Narrative

Date: July 31, 2026
Project: 24047 – NKU Civic Center Renovation
From: Jeff Fackler
Narrative: Addendum C

L5.00 – Planting Plan

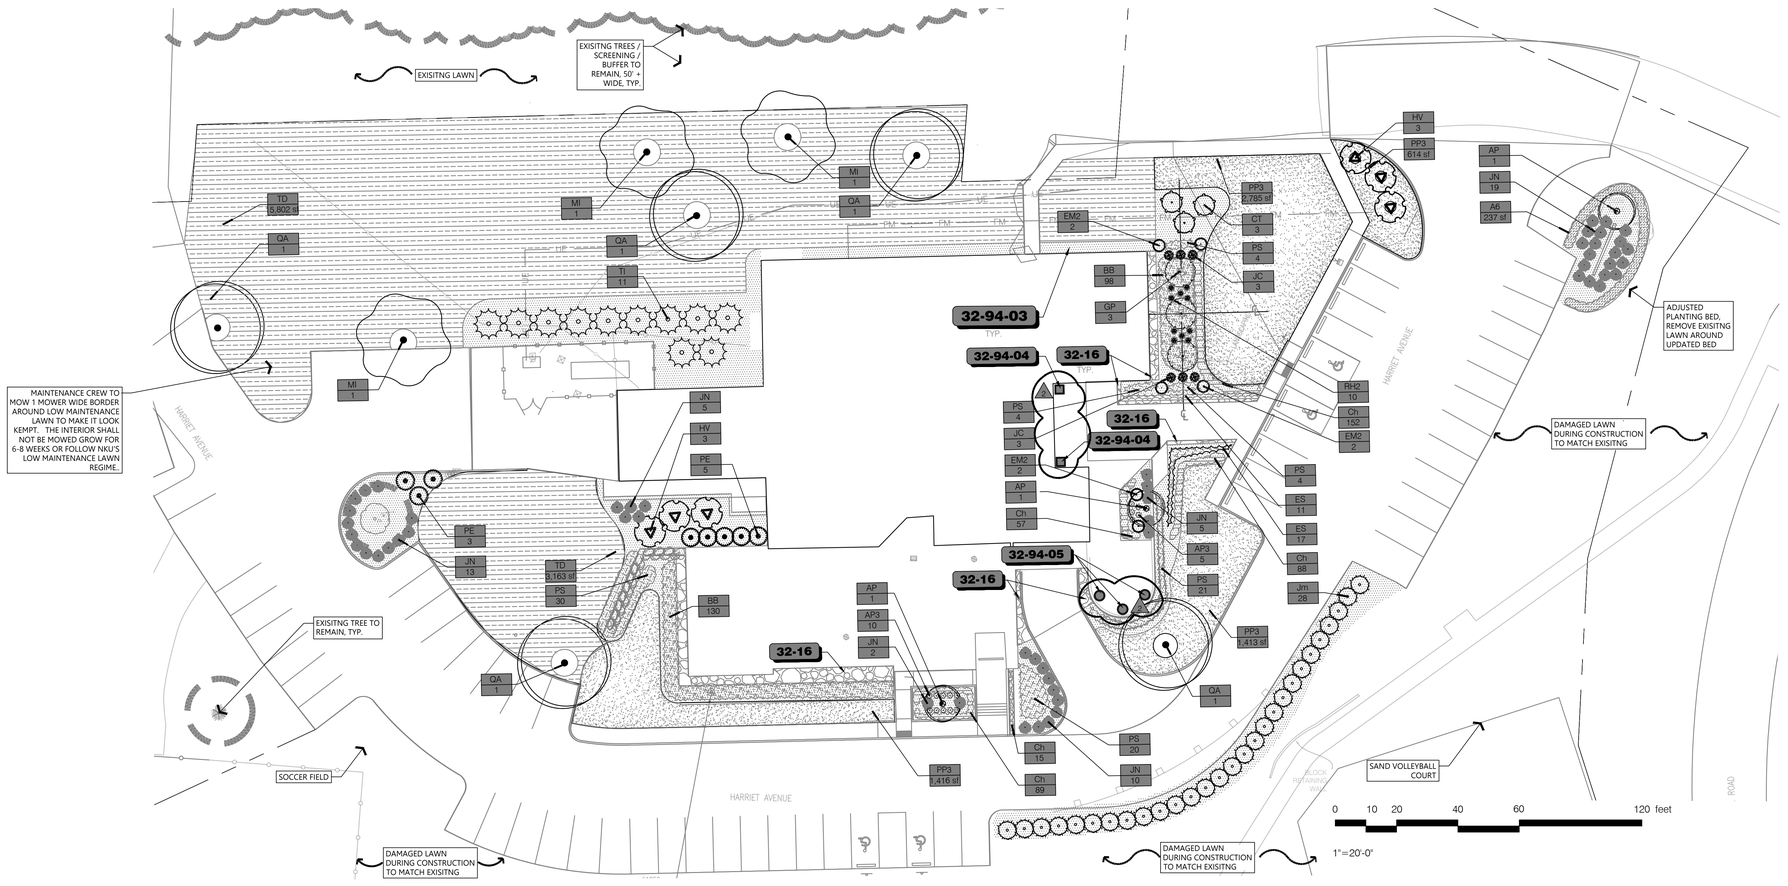
Areas previously designated as sod, shall be seeded in accordance with the revised landscape plans and specifications.
Planters shall be Owner Furnished, Owner Installed (OFOI). Contractor shall coordinate installation locations as shown on the plans.
The stone has been called out as 2-3" Commodity Slate.
Seeding notes have been revised to reflect updated timing requirements for Tall Fescue establishment.

SD100 - Existing Foundation Plan

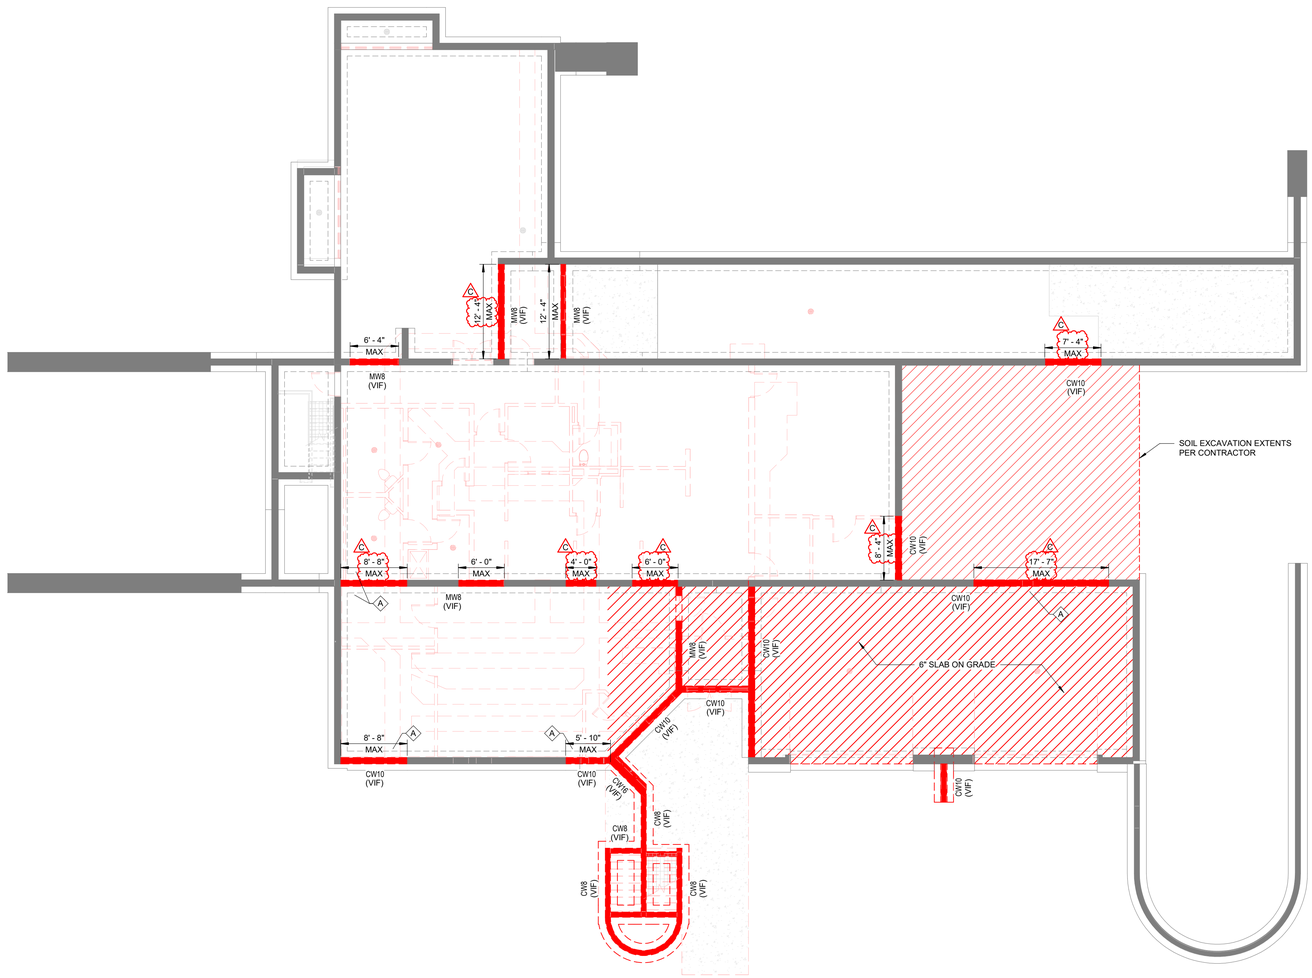
Revise several opening dimensions.

SD110 - Existing Floor Framing Plan

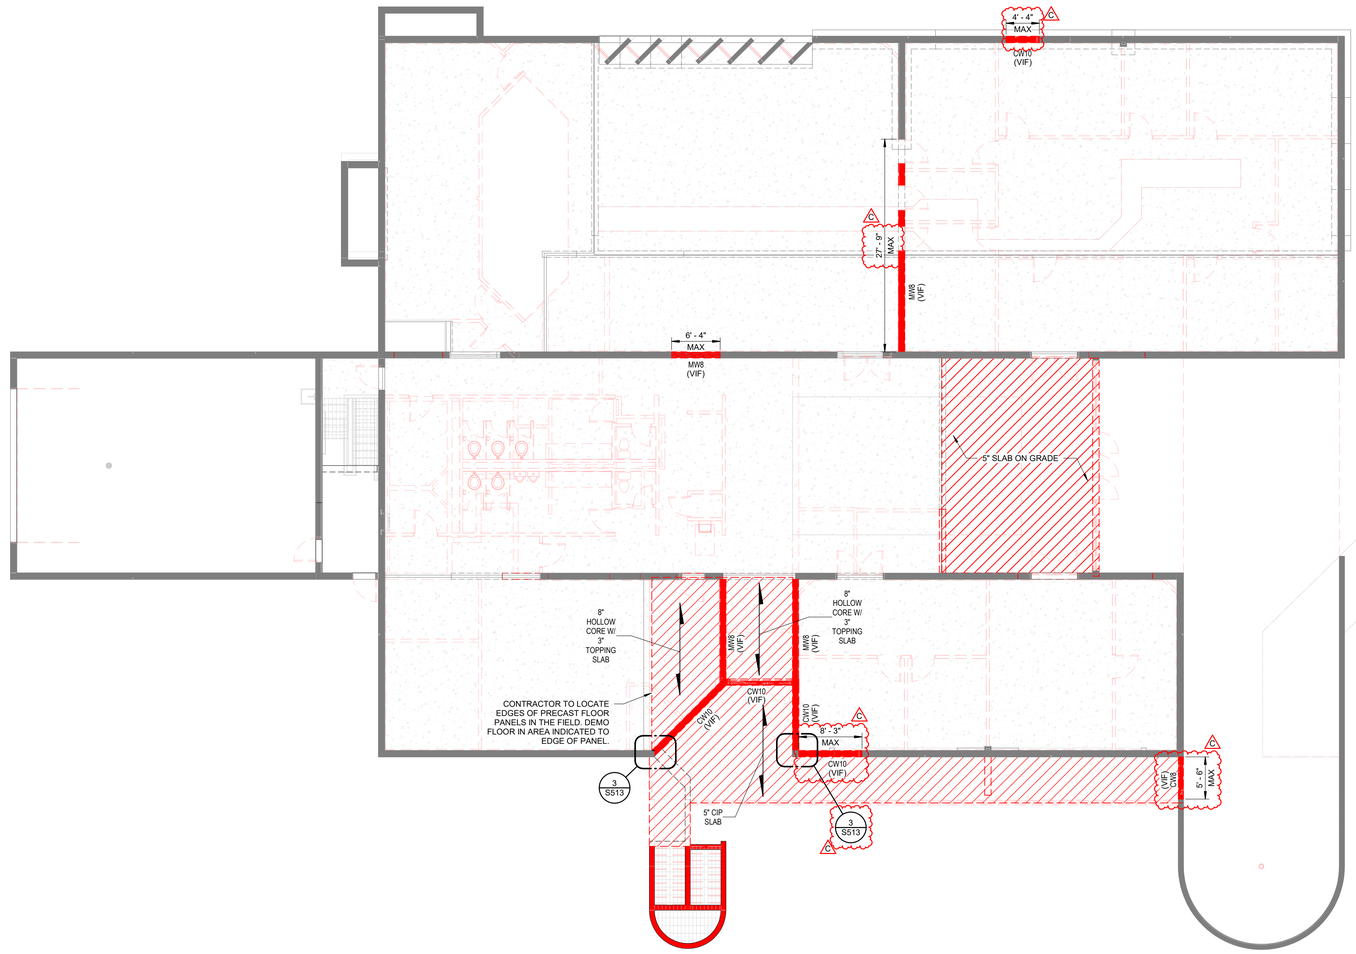
Revise several opening dimensions.
Add new detail for new post structure.

S110 - First Floor Framing Plan

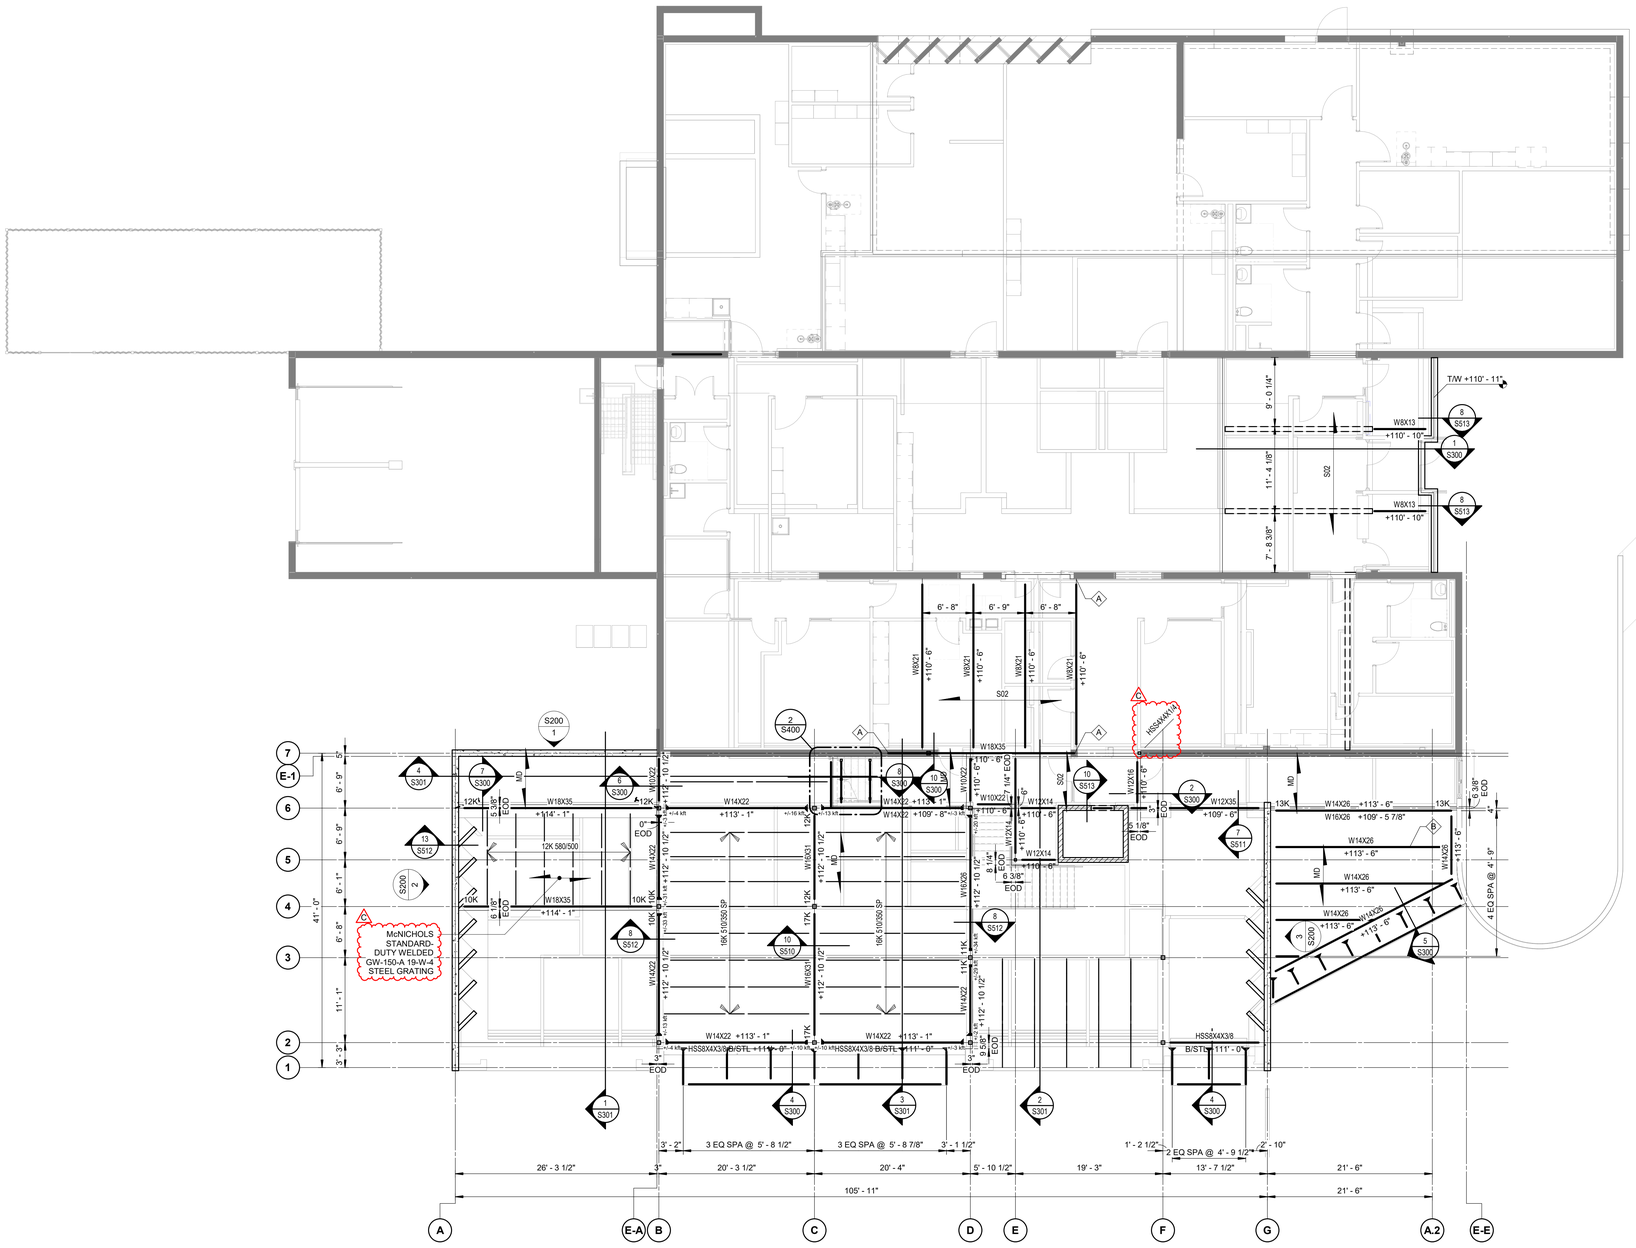
Add Basis of Design for grating decking at Mechanical Mezzanine.
Add additional steel reinforcement for existing concrete beam.

S301 - Addition Building Sections

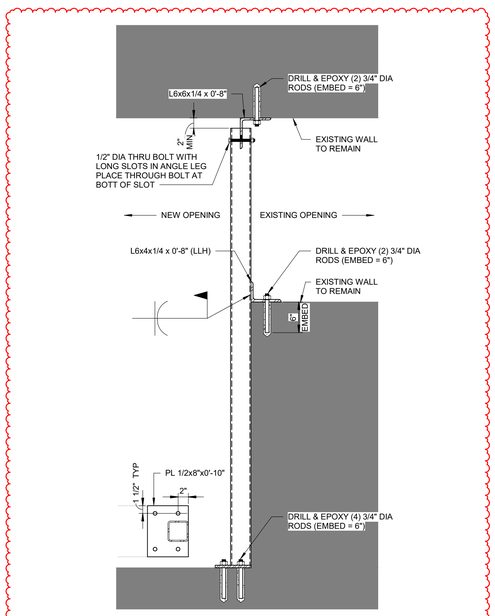
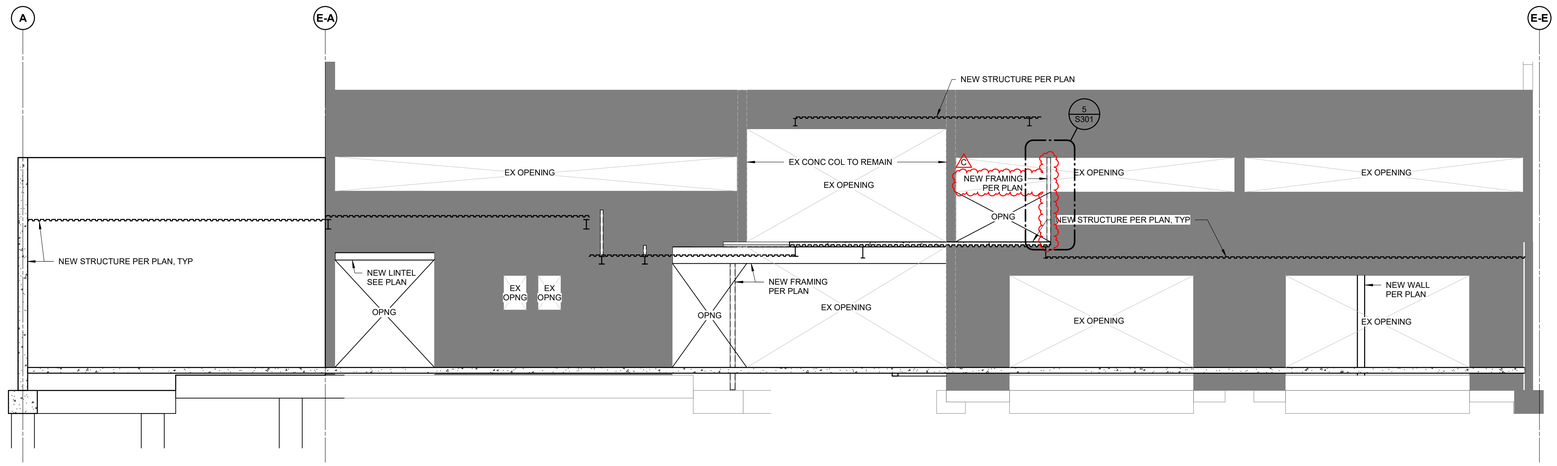
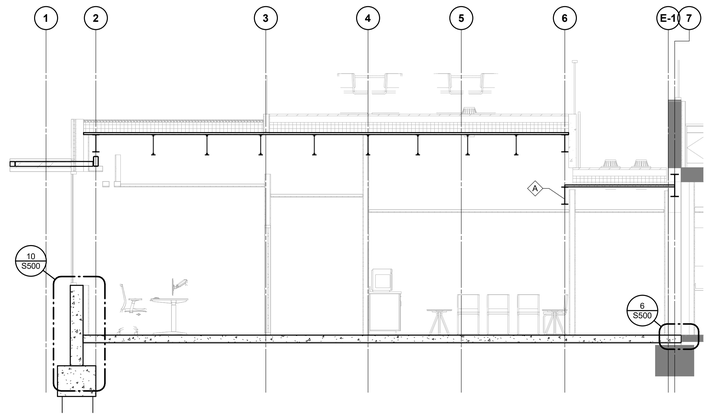
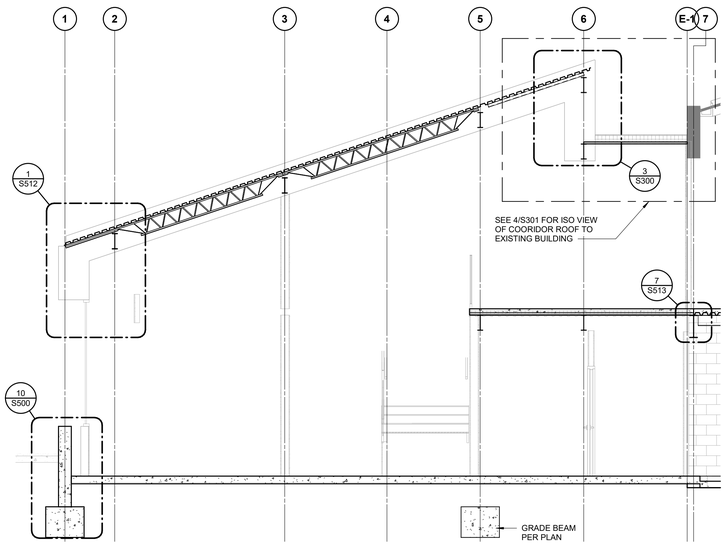
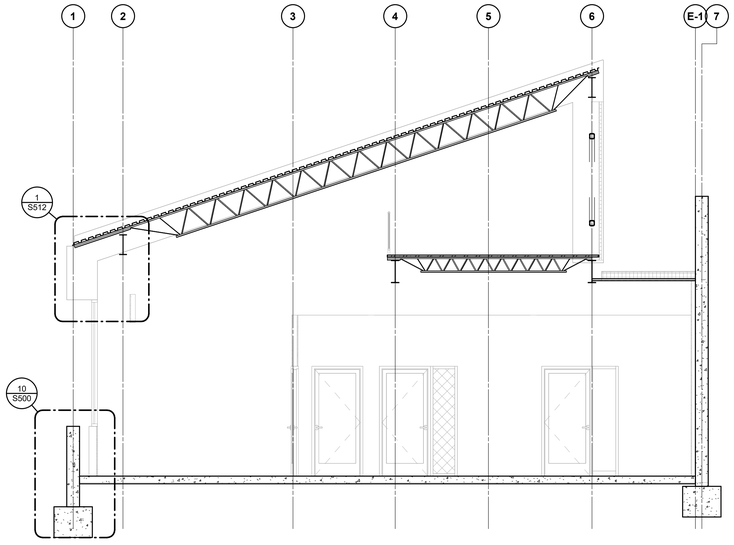
Add elevation and detail for new post connection.

S513 - Framing Schedules Sections & Details

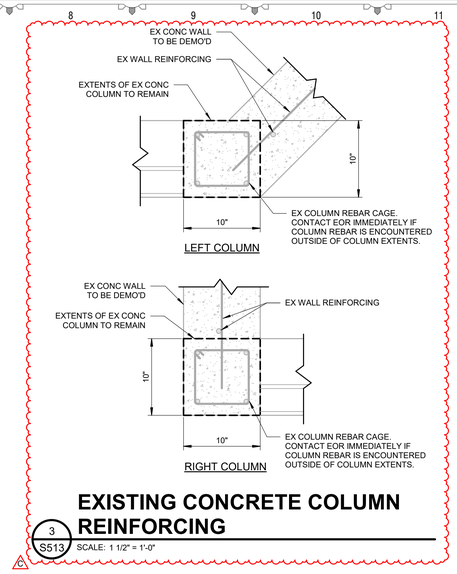
Remove decking type that is no longer in use.
Revise existing concrete column detail for additional demolition information.

D1.02 - Demolition Plan - Upper Level

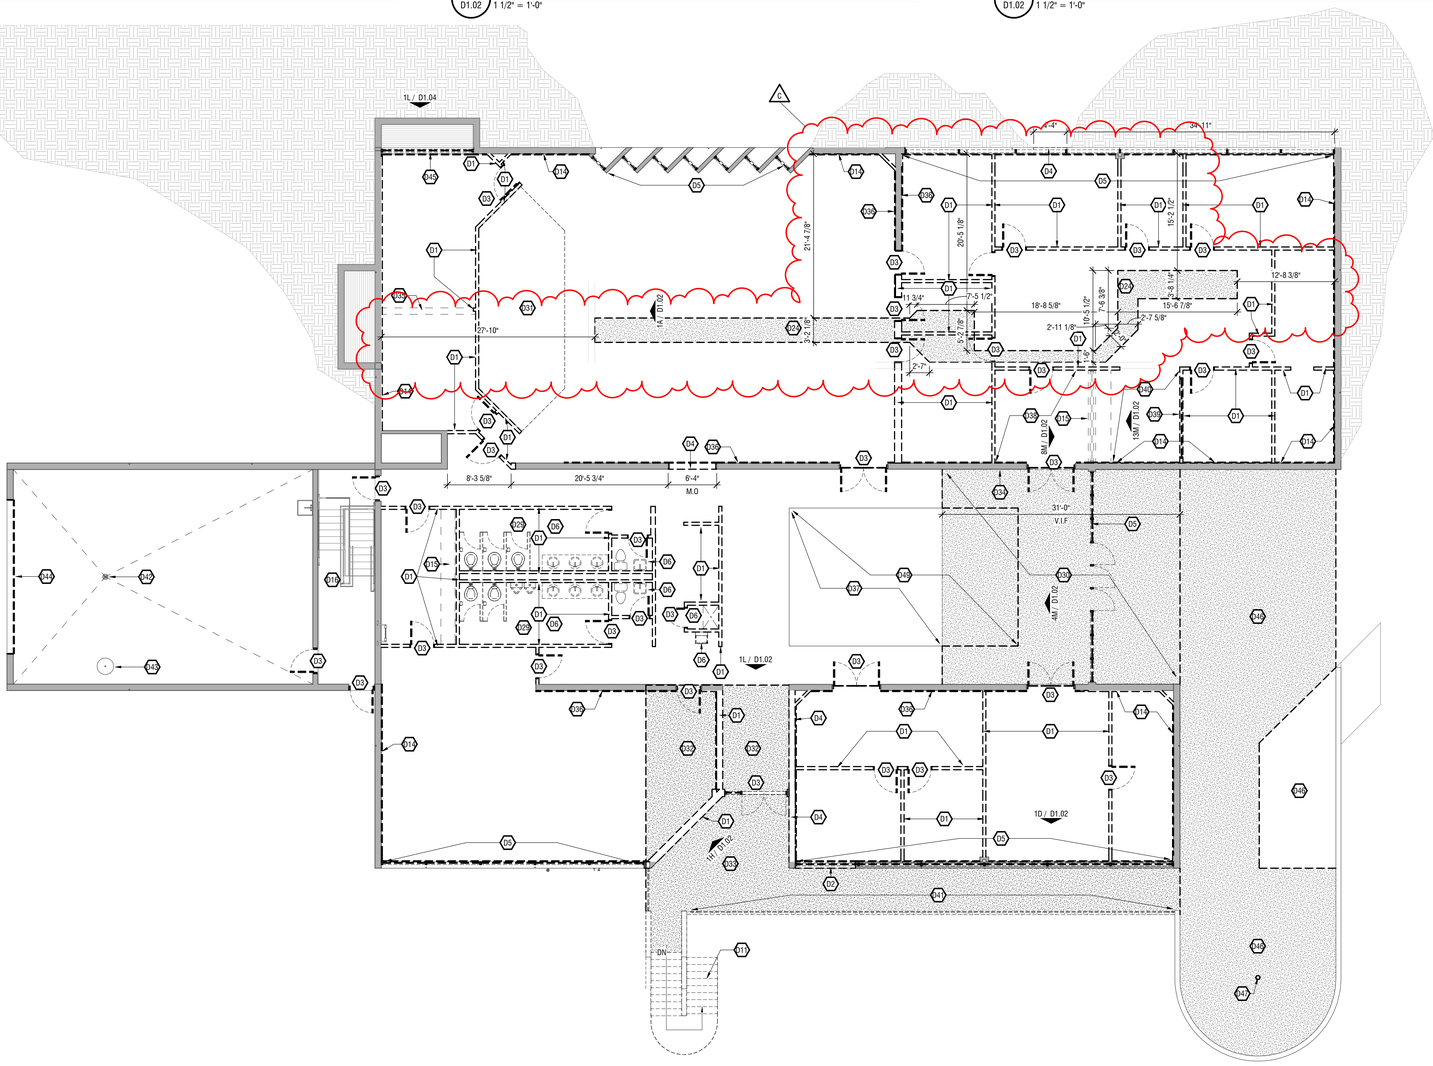
Add dimensions for cutting the existing floor slab for new plumbing.
